SERVICE INFORMATION LETTER SI 01.05

Machines/Models: LX series

PURPOSE: Improve braking endurance.

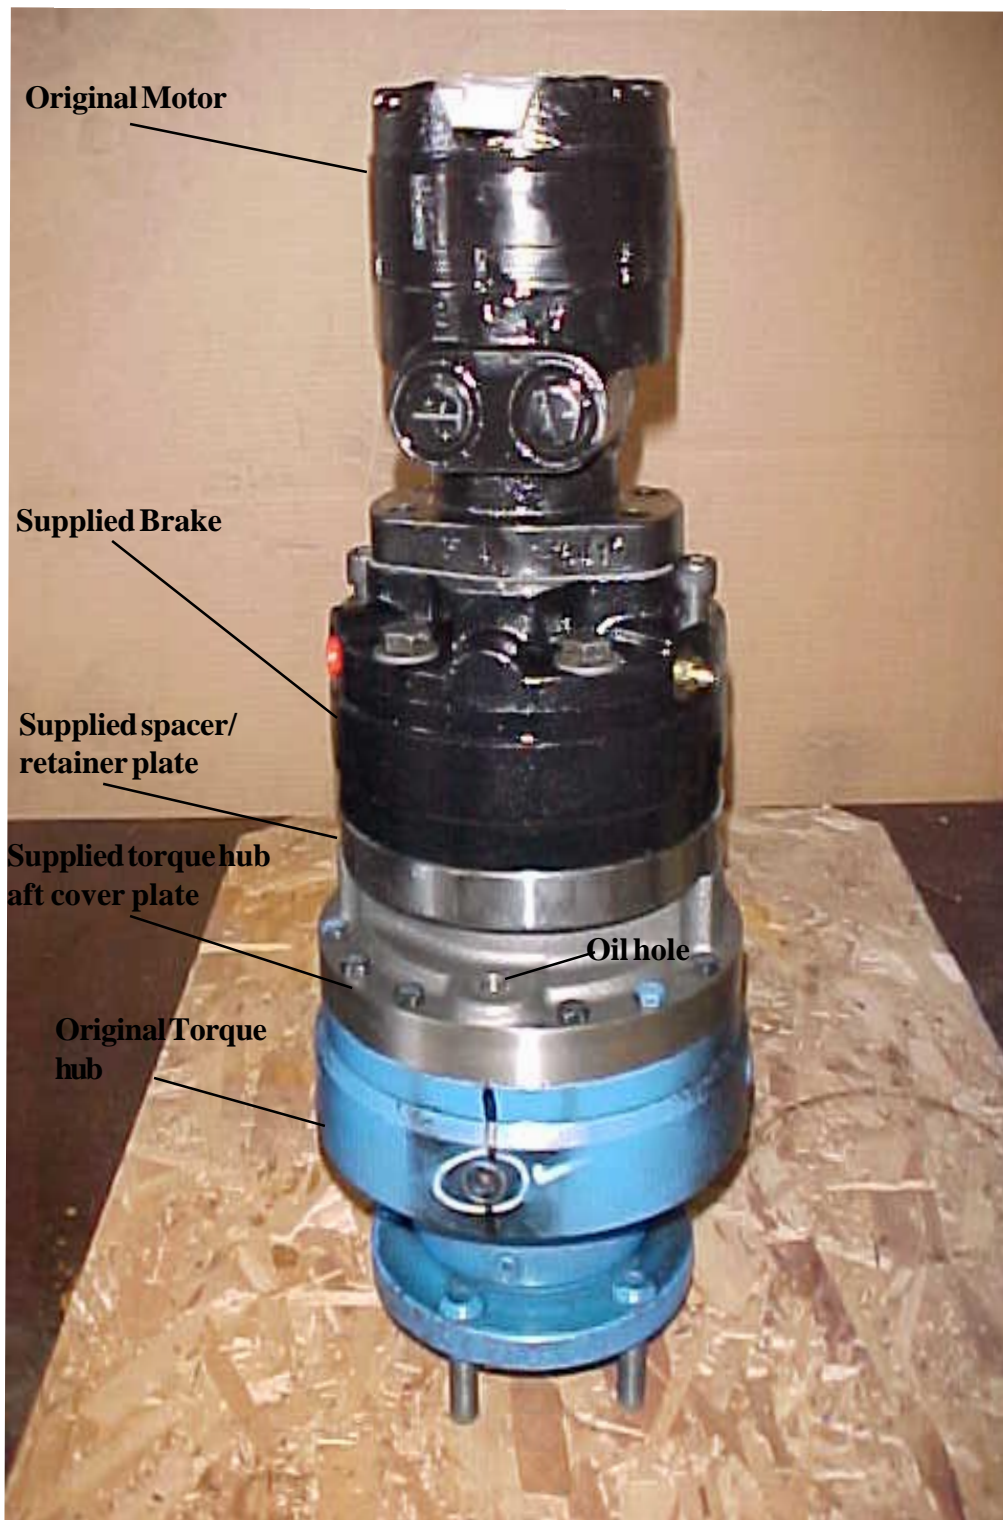
PROCEDURE REQUIRED: Remove the existing brake and shaft, modify planetary hub.

6. Draw an index line using a scribe or marker down the front of the torque hub assuring each part of the torque hub is marked. This will aid in the re-assembly.
7. Remove the oil fill plug from the rear cover plate and reinstall in the supplied rear cover plate.
8. Remove the twelve bolts securing the torque hub aft cover plate and discard the cover plate (retain the bolts for reassembly-note the 4 bolts that have specially machined shoulders for alignment).
9. Remove the sun gear (center splined shaft) from the planetary gears and discard.
10. Insert the supplied 1" spacer into the planetary gears (assure that it is bottomed out in the housing).

11. Insert the supplied sun gear (center splined shaft) into the planetary gears.
12. Install the supplied hub aft cover plate, using the supplied white o-ring (verify the alignment, refer to step 4) Align with the special shoulder bolts removed in step 5.

13. Install all twelve bolts and torque to 23-27 ft lbs.
14. Install the supplied thrust washer and o-ring into the supplied adapter plate (use of grease will help in retention and installation of o-ring and thrust washer).

15. Install new gasket and new brake to the back of the torque hub using the supplied 1/2 x 4-3/4 socket head mounting bolts and torque to 75 ft lbs (orient brake so that the oil ports are directed toward front as designated by index line applied in step 6).
